Re: *Application for Site Plan Approval*
Landscape Plan
Gateway Hotel
Oberlin College
7 North Main Street
City of Oberlin, Ohio

Subject: Application for Site Plan Approval
Revised Final Site Plan Submittal
Proposed Gateway Hotel Complex
College Properties of Northern Ohio, Inc.
Oberlin College
7 North Main Street

Date: July 1, 2014

**SITE LANDSCAPE
PLAN**

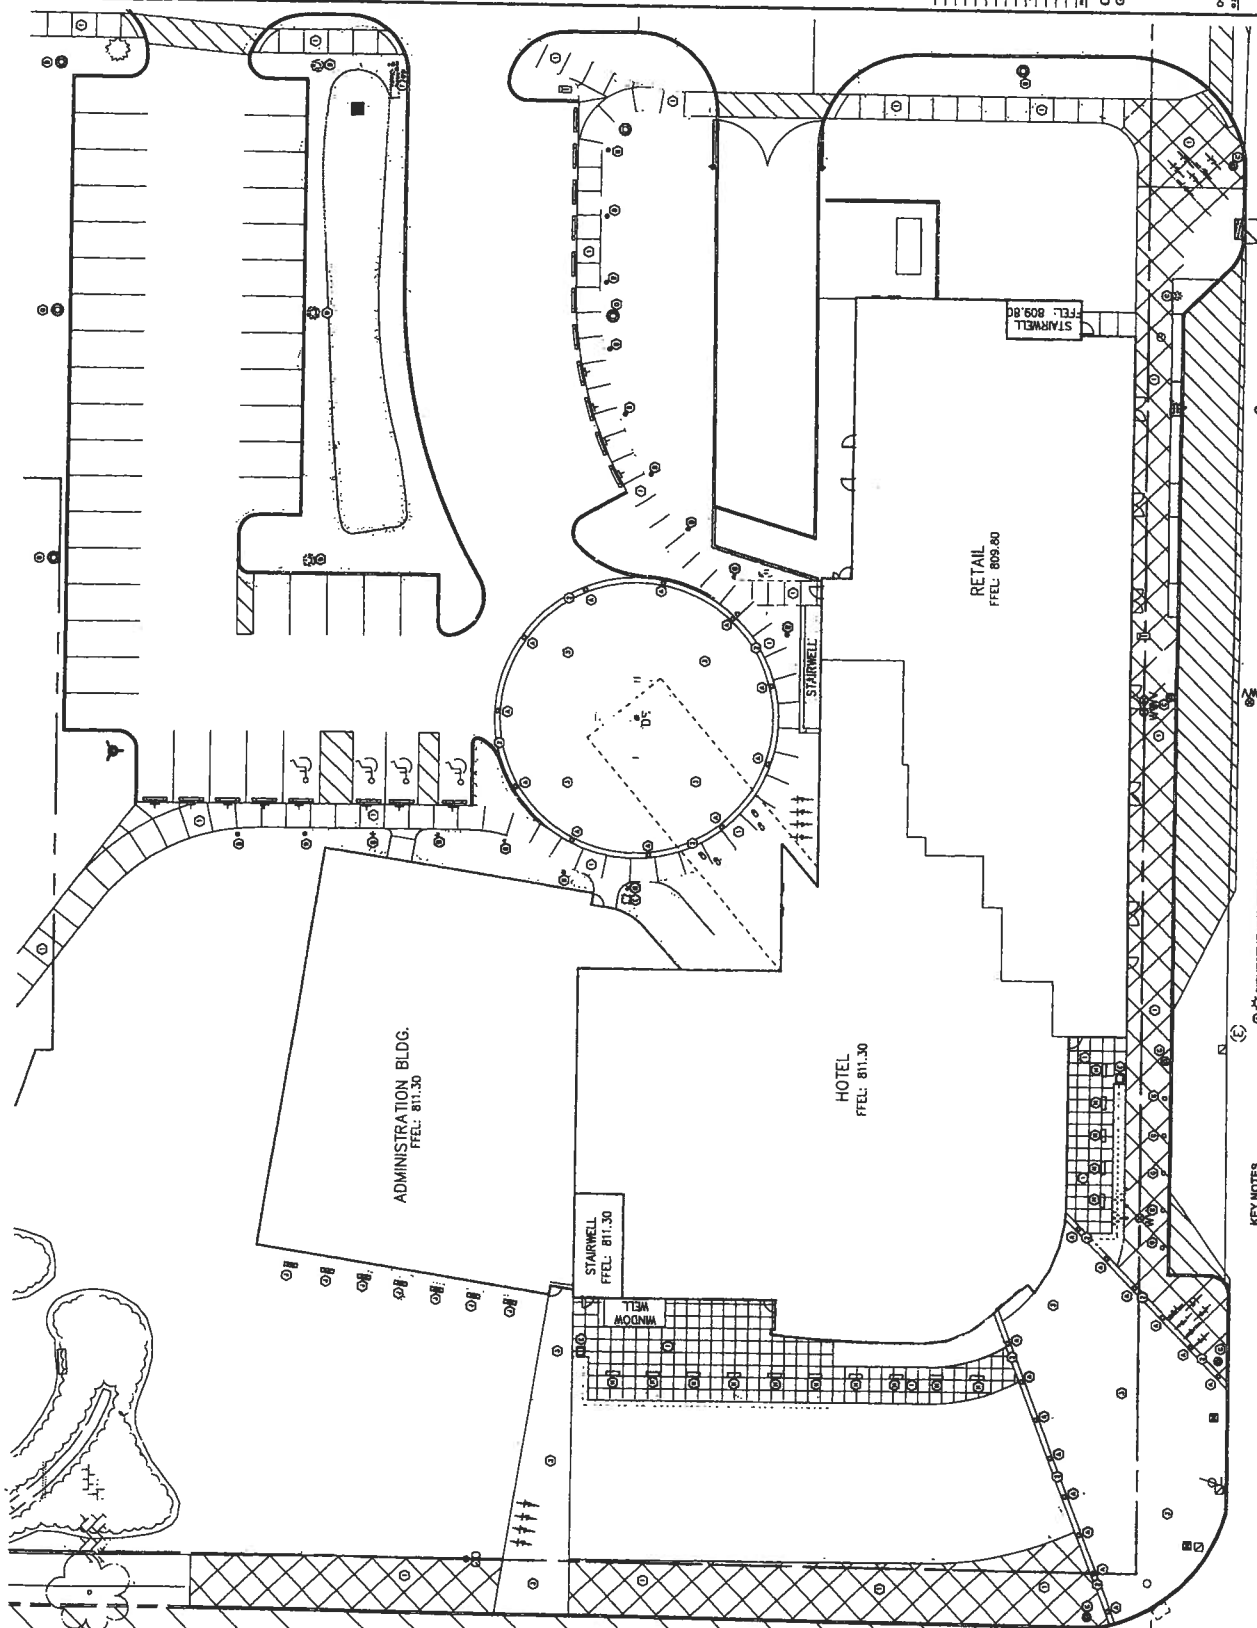
**LANDSCAPE PLAN RECOMMENDED FOR APPROVAL
BY THE DESIGN REVIEW SUBCOMMITTEE
ON JUNE 18, 2014**
